Subject: Request for Site-Specific Design of Stabilization Measures in Selected High-Hazard Portions of the Route of the proposed Atlantic Coast Pipeline Project in the Monongahela National Forest and George Washington National Forest
OEP/DG2E/Gas 4
Atlantic Coast Pipeline, LLC
Docket Nos. CP15-554-000 and CP15-554-001

U.S. Forest Service Request for Site-Specific Design of Stabilization Measures in Selected High-Hazard Portions of the Proposed Atlantic Coast Pipeline Route

Attachment A:

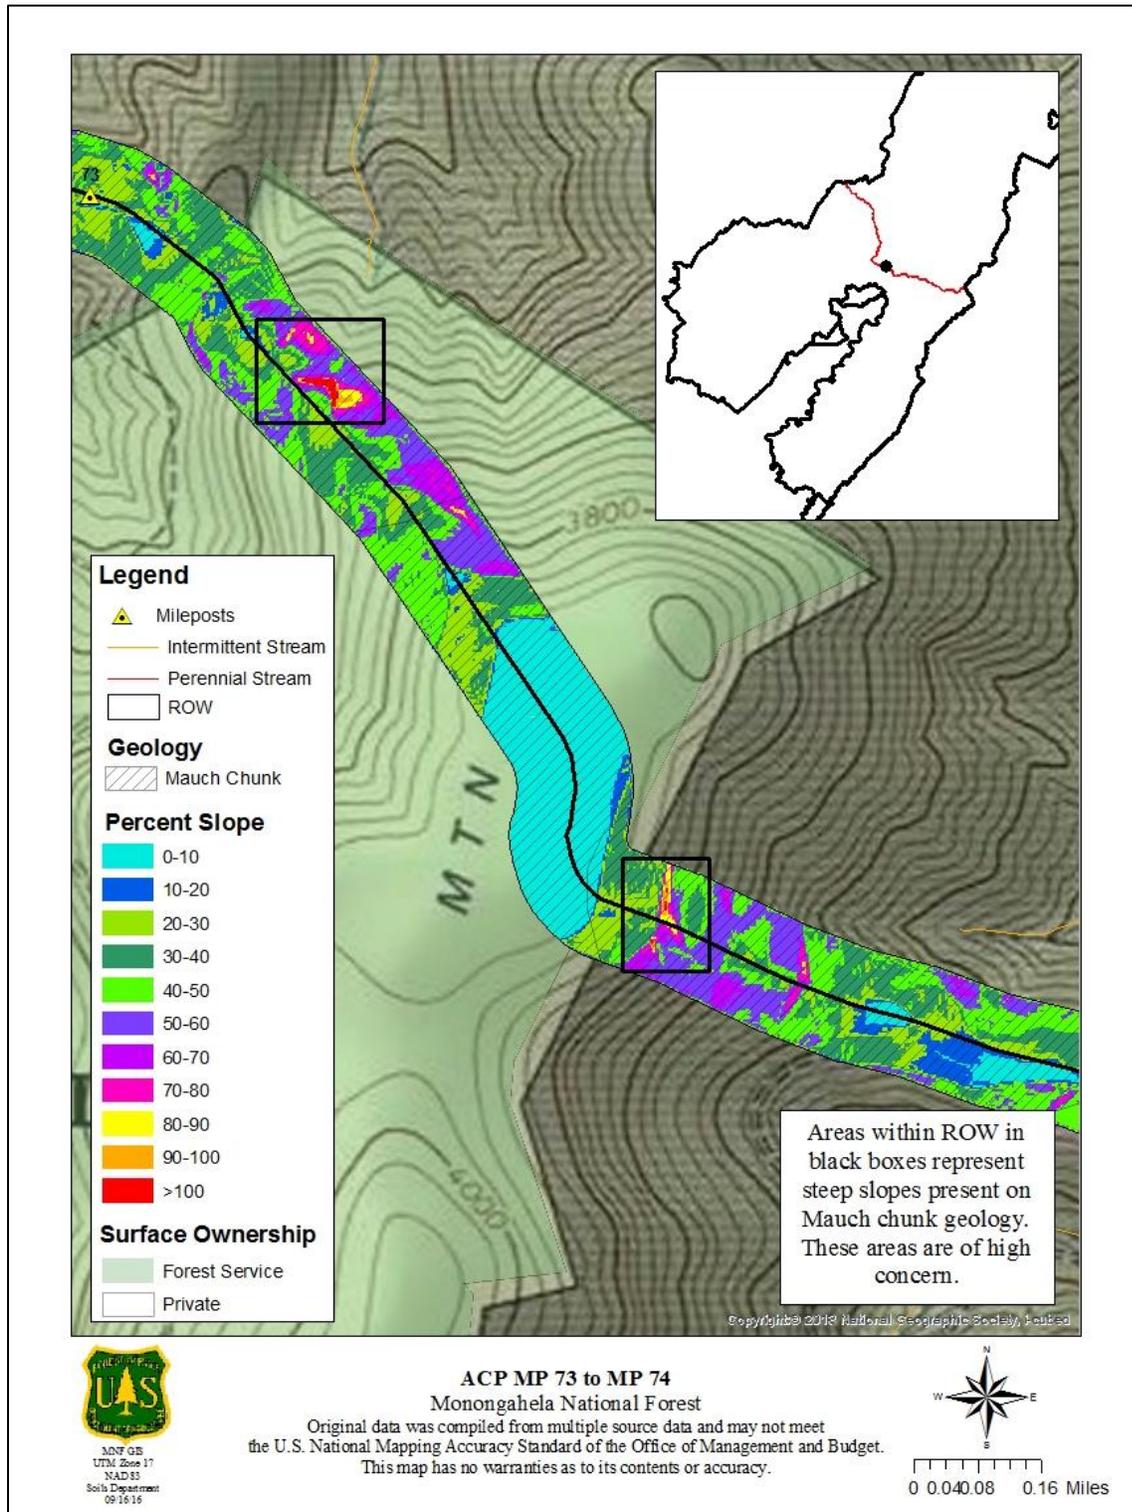
MNF Site 1 (Attachment A)

Between ACP's Mileposts 73 and 74 where the buffered ROW will cross areas with slopes of 80-90, 90-100, and >100% and which are also present on Mauch Chunk geology. This area of concern is presented on public land and also on private land.

ACP MP 72 to MP 73

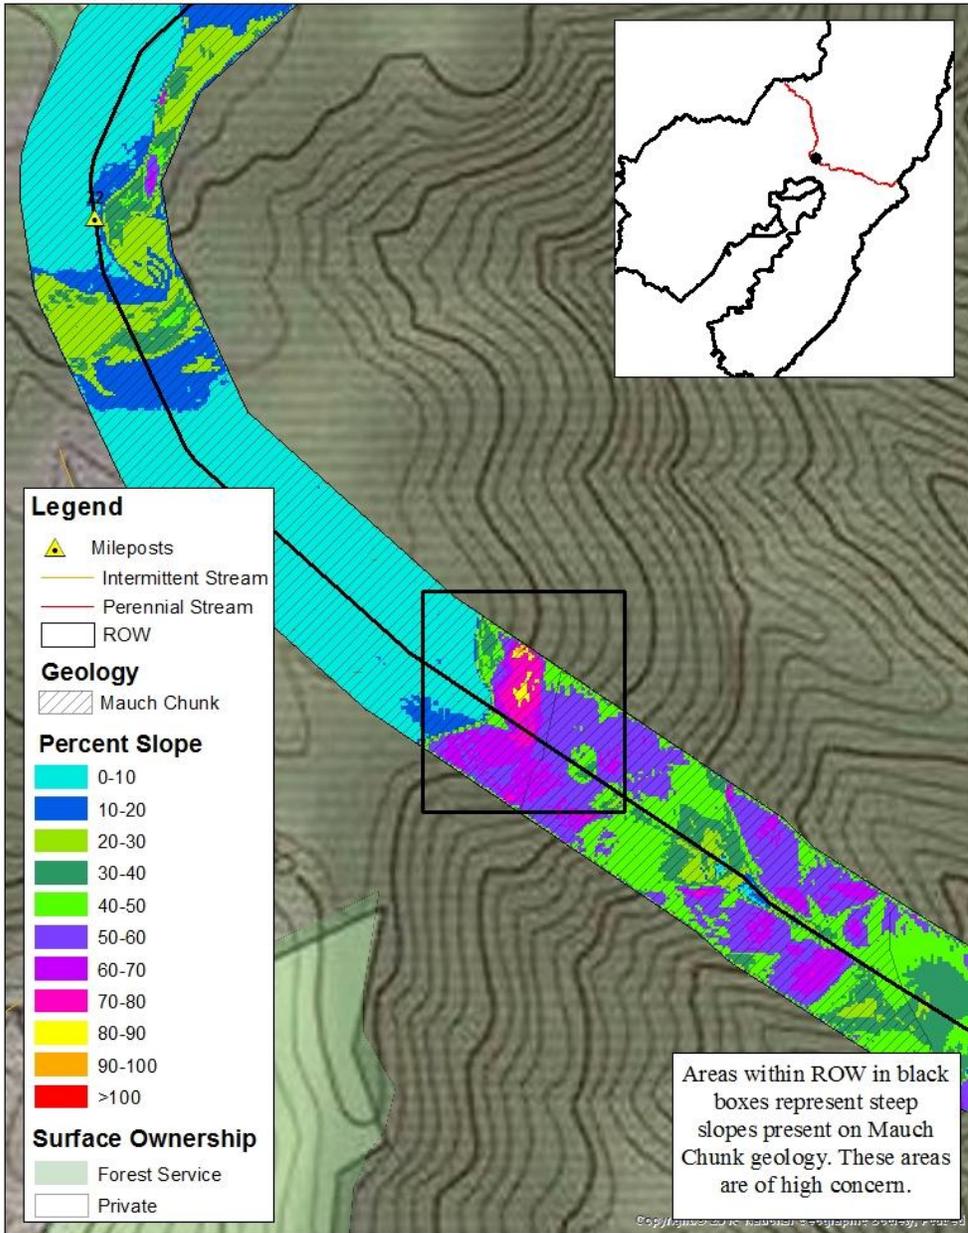
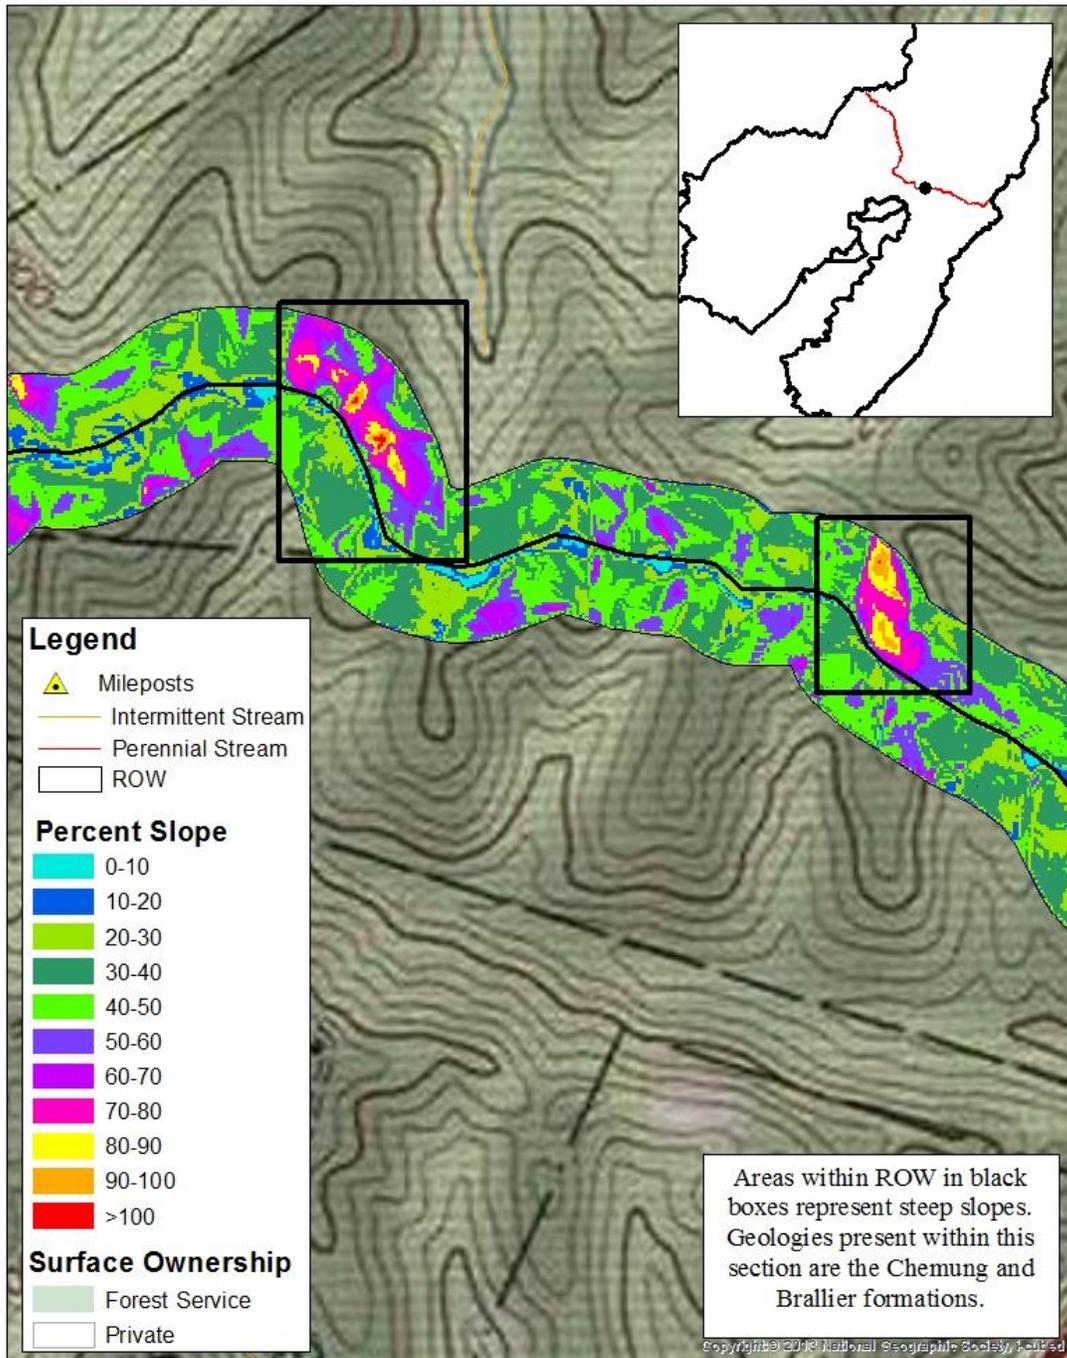
MNF Site 2 (Attachment B)

Between ACP's Mileposts 72 and 73 where the buffered ROW will cross areas with slopes of 60-70, 70-80, and 80-90%. These areas are also present on Mauch Chunk geology on private land.

ACP MP 82 to MP 83
Monongahela National Forest

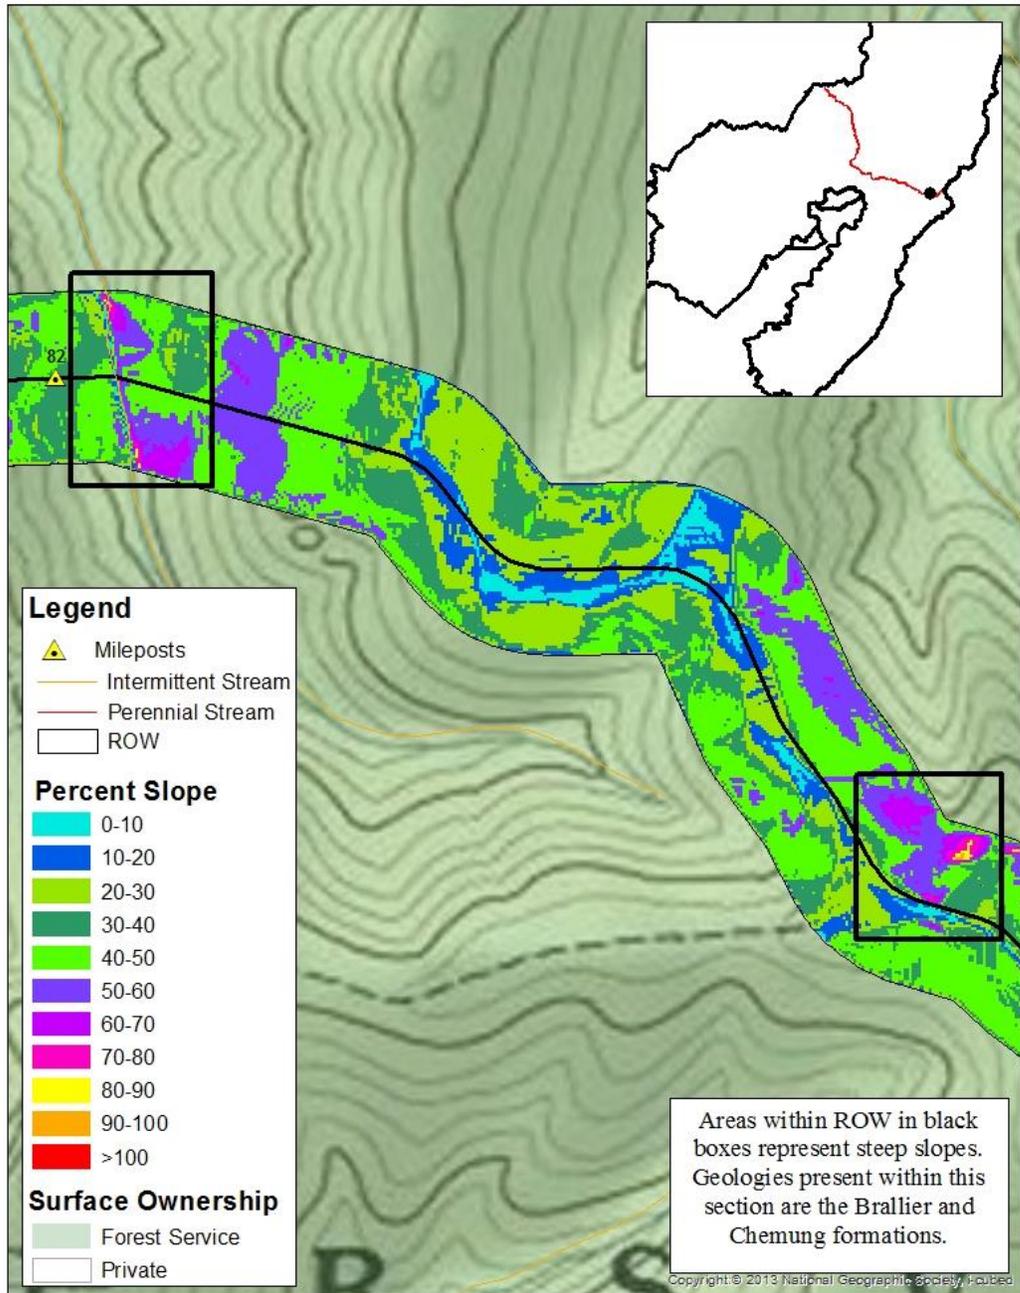
MNF Site 4 (Attachment D)

Between Mileposts 82 and 83 where the buffered ROW and centerline intercepts an intermittent stream, 60-70, 70-80, and 80-90% slopes. These areas of concern are present on public land.
